Watts Bar Nuclear Plant (WBN)
Proposed License Approach Regarding a Change for the WBN Units 1
and 2 Technical Specification (TS) 3.3.2 Table 1 Function 6.e “Auxiliary
Feedwater Auto - Start from Loss of Main Feedwater Pumps”

August 11, 2020

Proposed design for AFW auto-start initiation logic with the addition of the Standby Main Feedwater Trip channel

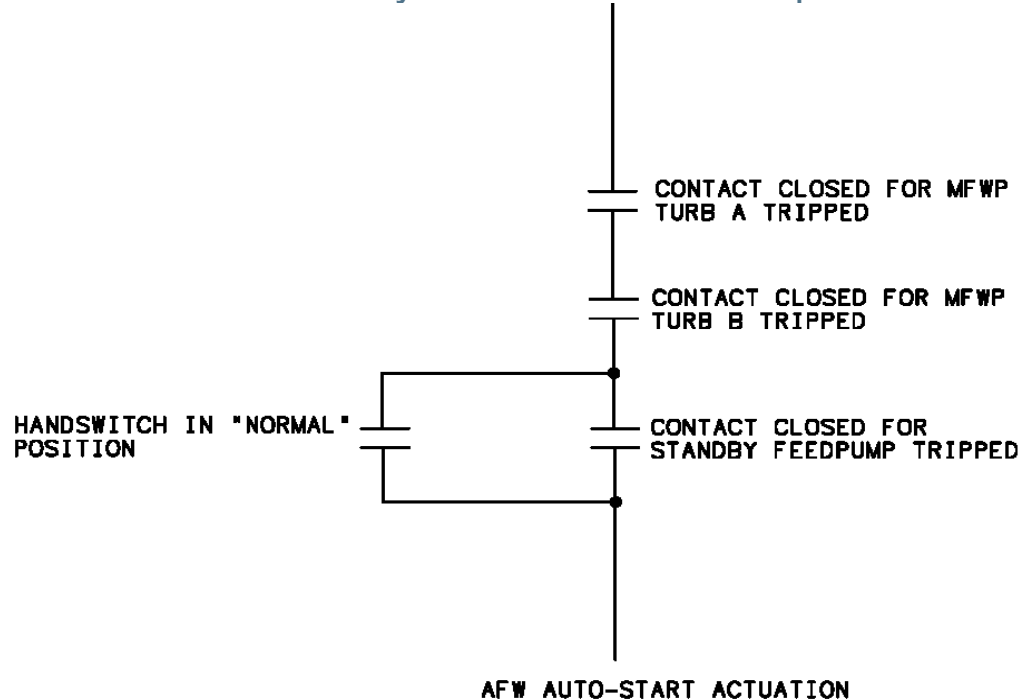
- Revise the AFW Auto-start Logic
 - The addition of SBMFWP power supply breaker contact interface to the AFW Auto-start Logic
 - The breaker contact will close when breaker is open.
 - This will make the AFW auto-start logic initiate from the trip of all MFW pumps both TDMFPs and the SBMFP
 - The SBMFP trip channel will be provided with a handswitch that allows the operations staff to place the channel in trip when the SBMFP is not operable.
- The revised circuitry will remain as an anticipatory AFW auto-start function and will not be credited in the WBN accident analyses.
